MEMO

Re: Review for an Addition to 63 S. Riverview Street

5. South elevation of the proposed addition by the applicant. The numerous dormers overwhelm the structures and detract from the historic core of the building. The height of the new garage needs to be reduced so it is clearly an outbuilding or accessory structure and not part of the main building.

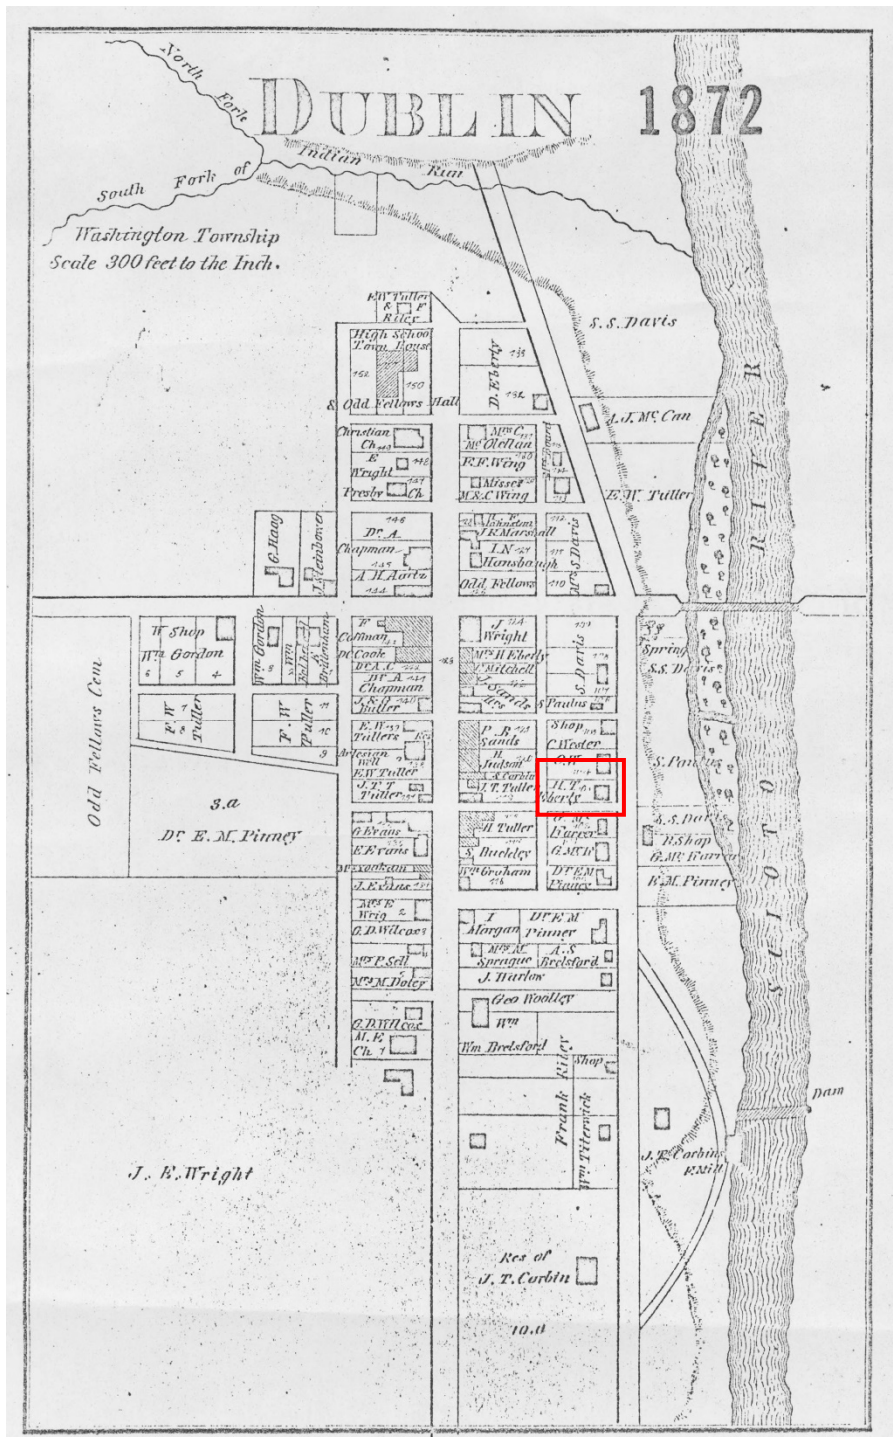
The Secretary of Interiors Standards for Rehabilitation state that new work will be compatible with the historic features, size, scale, and proportion. While the footprint of the new garage addition (approximately 26'x36') is almost the same as the existing concrete block garage (40'x24'), it overwhelms the historic dwelling in height, mass, scale, and proportion. It is as tall as the historic core and should be reduced in height. In addition, it has a shed dormer on the east side and a gable dormer on the west side that overpower the original building in mass and scale. The historic dwelling is a simple end gable roof structure of one-and-a-half stories. The proposed addition introduces too many visual elements in the various dormers and rooflines that detract from the historic structure and compete for attention. Rather, the new addition should contain similar simple stylistic features that complement the historic building. The original dwelling set the style that should be used in any new additions; the numerous shed dormers, gable dormers, and end dormers do not appear in the original structure. While one or two new additional features may be appropriate, the combination of numerous dormers and rooflines create a distraction and is not compatible with the historic structure or the district overall.

6. Quick sketch of a simplified south elevation. The windows of the second-floor master suite now align with those below and a simplified roofline complements the original structure. The garage addition is reduced in height and its dormers removed so it does not compete with the original building.
